**COUNTY OF SANTA BARBARA  
PLANNING AND DEVELOPMENT**

**MEMORANDUM**

SUBJECT: Additional hearing on the Diamond Rock Sand & Gravel Mine and Processing Facility; Conditional Use Permit 03CUP-00000-00037, and Reclamation Plan 03RPP-00000-00002. APN 149-220-002, -011 and -065, Fifth Supervisorial District.

## **3.0 OFFICE OF MINE RECLAMATION COMMENTS**

**Figure 4 – Reclamation Plan**

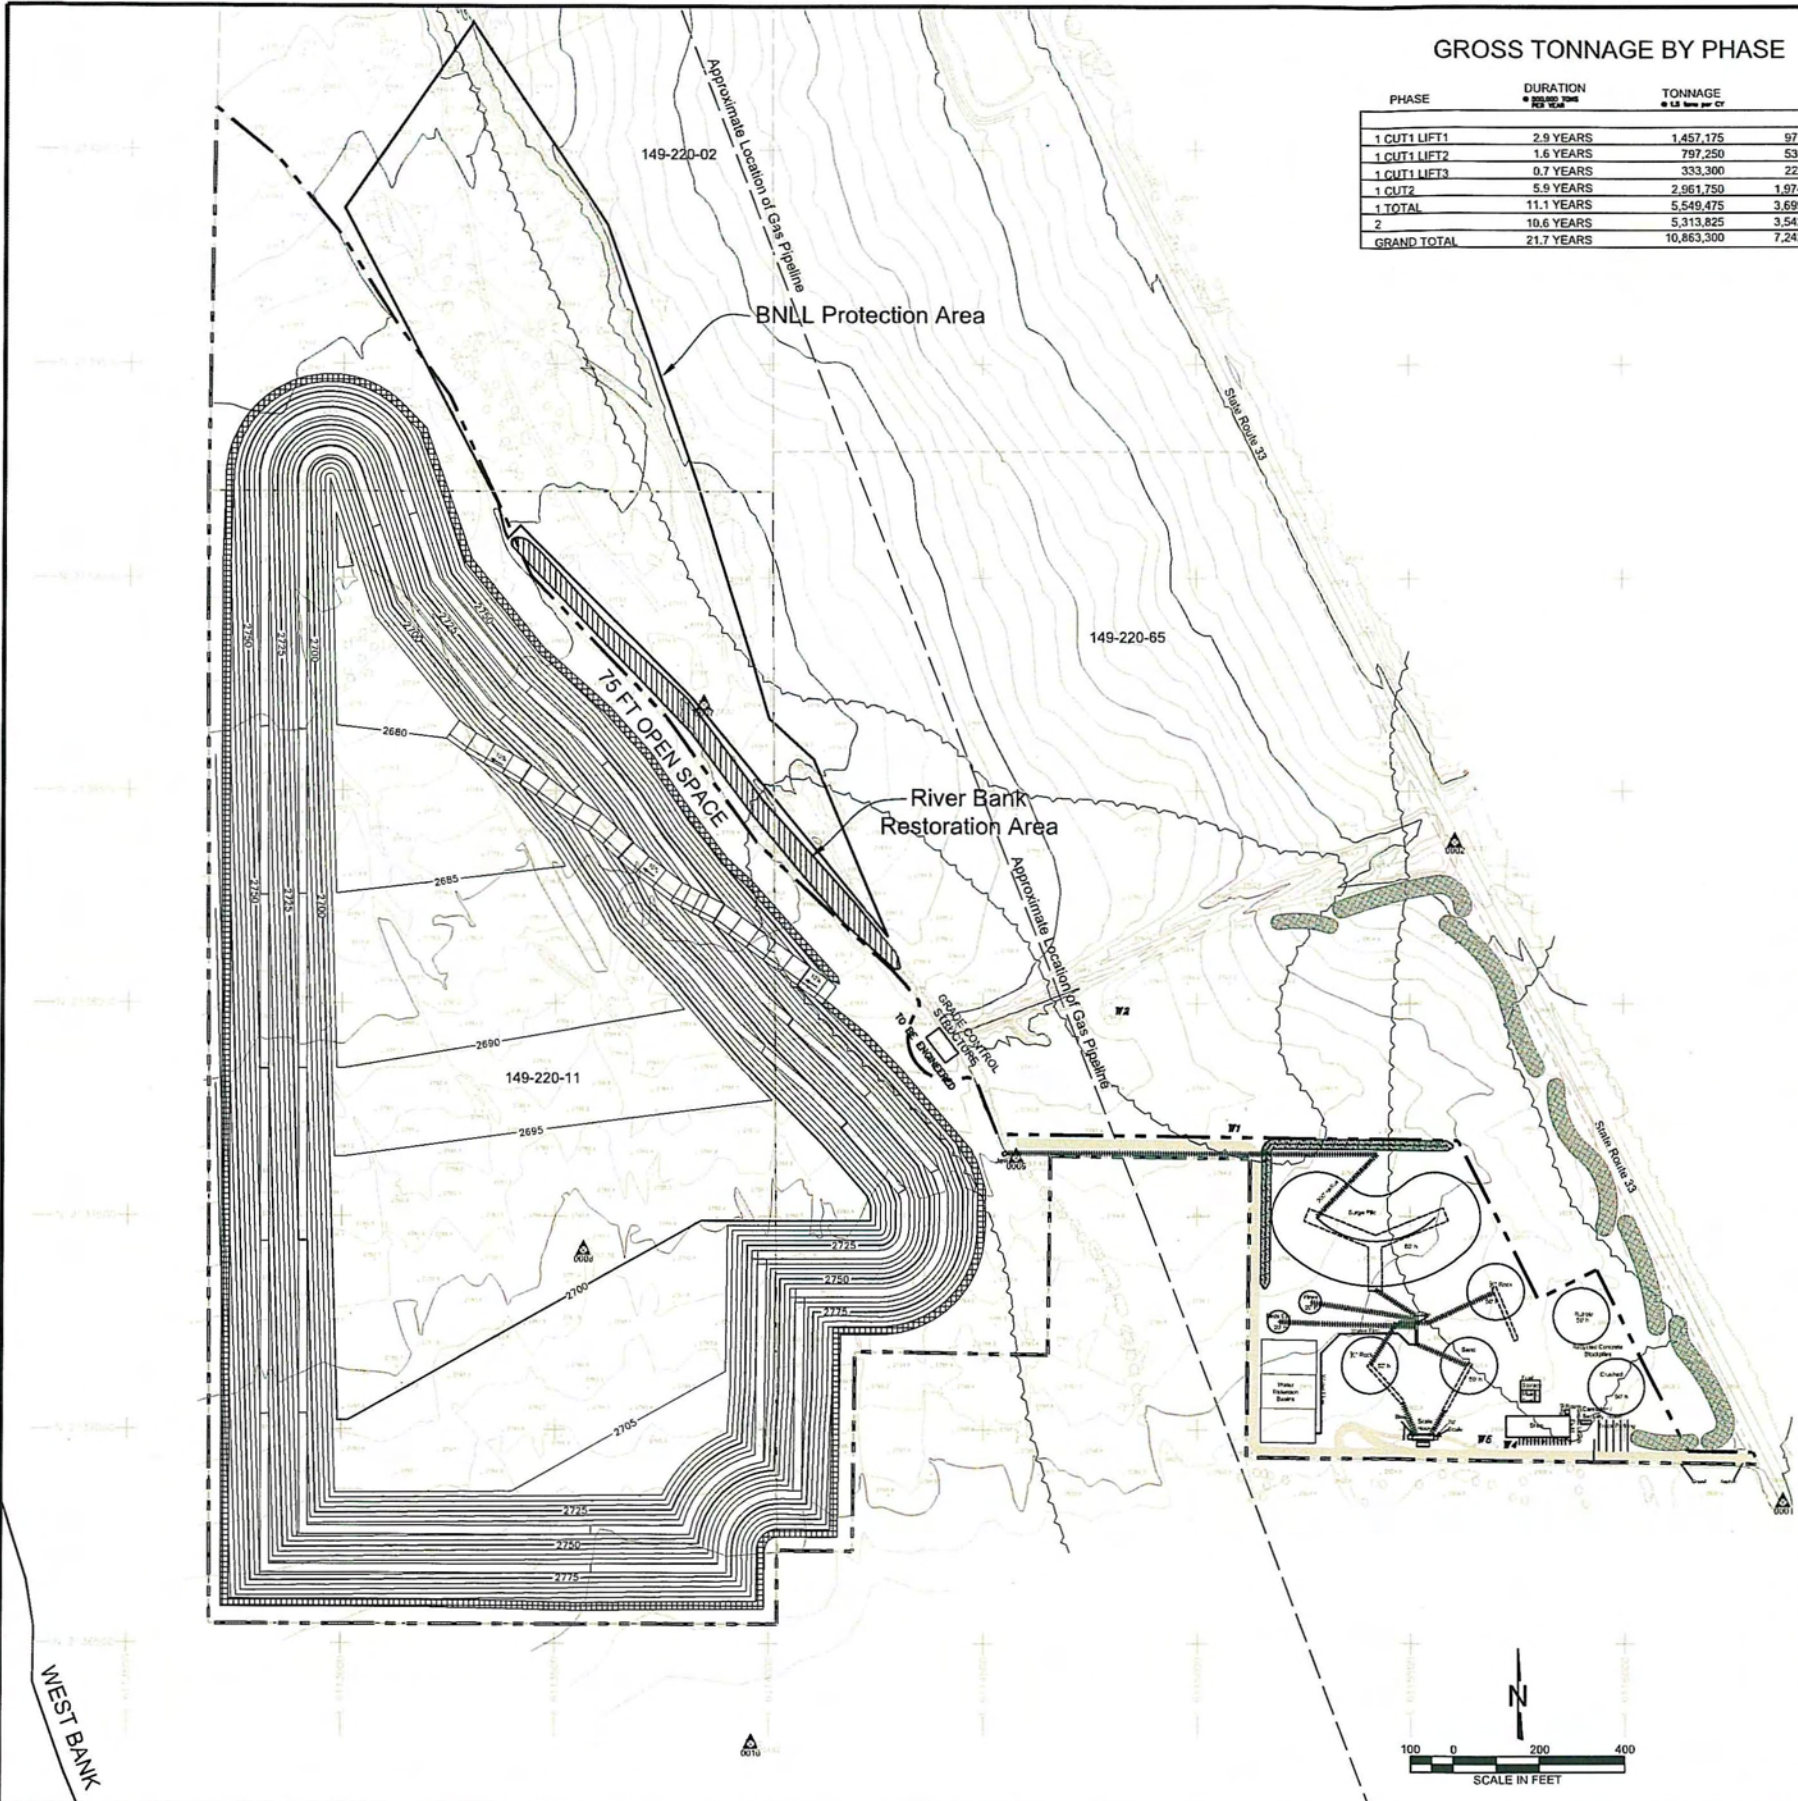
3. **Project map clarifications.** The project applicant has revised Reclamation Plan Figures 4, 4a, 6 and 7 so that the proposed mine pit contour lines are legible. Figures 4, 6 and 7 now depict mine pit elevation contours that would be developed should the southeastern mine pit boundary be permanently modified pursuant to the requirements of Reclamation Plan Condition of Approval No. 2 (i.e., provide a 900-foot setback from the west bank of the Cuyama River). Figure 4a depicts mine pit contours that would be developed should it be subsequently determined that the 900-foot buffer is no longer required to minimize project-related hydrologic impacts.

- 7.c **Modified mine pit boundaries.** Reclamation Plan Figures 4, 6 and 7 now depict the revised configuration of the southeast corner of the mine pit to show the 900-foot setback from the western bank of the river.

- c. As described above, the modified mine pit boundary is shown as a line on Figure 4. A separate figure should show finished slopes associated with the modified mine pit boundary.

3. The project applicant has revised Reclamation Plan Figures 4, 4a, 6 and 7 so that the proposed mine pit contour lines are legible, and full size copies of those figures are enclosed with this letter. Figures 4, 6 and 7 have been revised to depict mine pit elevation contours that would be developed should the southeastern mine pit boundary be permanently modified pursuant to the requirements of Reclamation Plan Condition of Approval No. 2. Figure 4a depicts mine pit contours that would be developed should it be subsequently determined that the 900-foot buffer is no longer required to minimize potential hydrologic impacts. Other items added to the maps include the location of the

- 7.c Reclamation Plan Figures 4, 6 and 7 depict the revised configuration of the southeast corner of the mine pit, and were provided to OMR by the project applicant on November 8, 2007. The same maps have been included in the final Reclamation Plan and are enclosed with this letter.
8. A SWPPP has been prepared for the Diamond Rock project and is generally described in section 4.5.13 of the Reclamation Plan. In addition, Section 6.7 of the Reclamation Plan has been amended to include language describing the Stormwater Monitoring Plan and stormwater percolation swale developed for the project. Prior to ground disturbance, a notice of Intent (NOI) will be filed with the RWQCB and a final SWPPP will be developed and submitted to the County. A description of erosion control measures for the mine slope can be found in section 7.5 of the Reclamation Plan.

10. As indicated in response No. 3, Reclamation Plan figures 4, 4a, 6 and 7 have been revised to depict the location of the proposed flood control berm. Details of the berm construction can be found in Section 4.5.9 of the Reclamation Plan.

**Figure 4a – Reclamation Plan  
Excluding modified mine pit boundary –  
Condition of Approval #2**

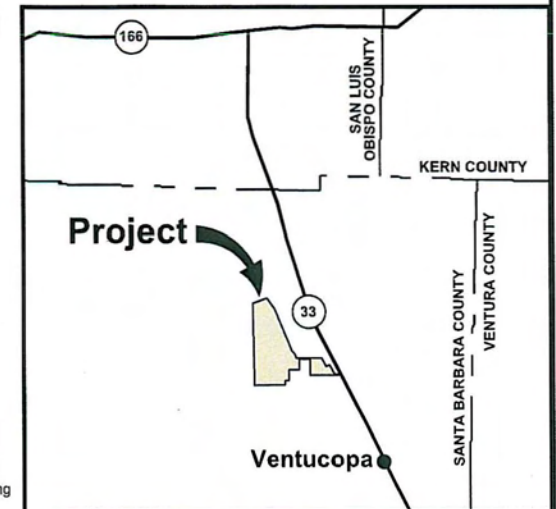
- Identify performance criteria that are to be used to define what and when actions will be taken to mitigate adverse hydraulic conditions.
10. **Show the proposed flood control berm on project plans.** Reclamation Plan Figures 4, 4a, 6 and 7 have been revised to depict the location of the proposed flood control berm. Details of the berm construction are provided in Section 4.5.9 of the Reclamation Plan.
